**Norfolk Boreas – 2nd Consultation on Applicant’s response to the Secretary of State’s
Additional Information Request**

NORFOLK BOREAS OFFSHORE WIND FARM

Planning Inspectorate Reference: EN010087

**Appendix 1: Updated Population Visibility Analyses (PVAs) and
implications for in-combination assessments for Flamborough and
Filey Coast Special Protection Area (FFC SPA)**

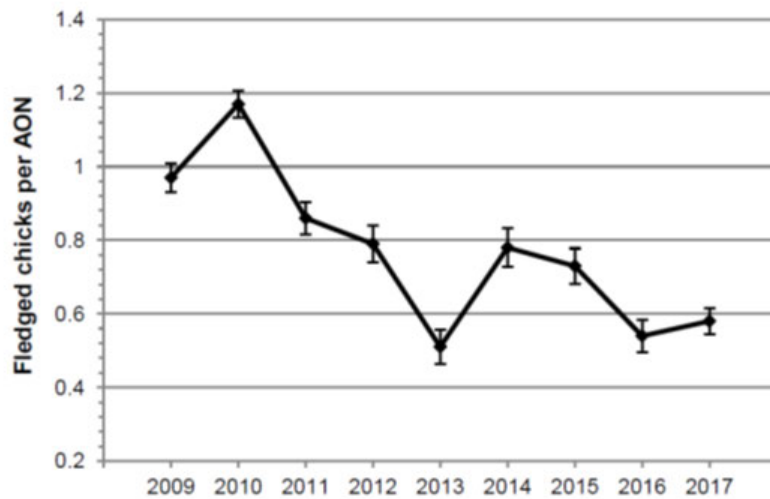
57. There is no evidence to suggest that the future population trend will be significantly different from the current trend of 0.37% per annum (2000-2017), for example productivity at the colony has not been increasing in recent years (see Figure A2.01)

(Aitken et al. 2017). So, based on the review of growth rates above, it seems reasonable to assume that the FFC SPA colony growth rate will be <1% per annum.
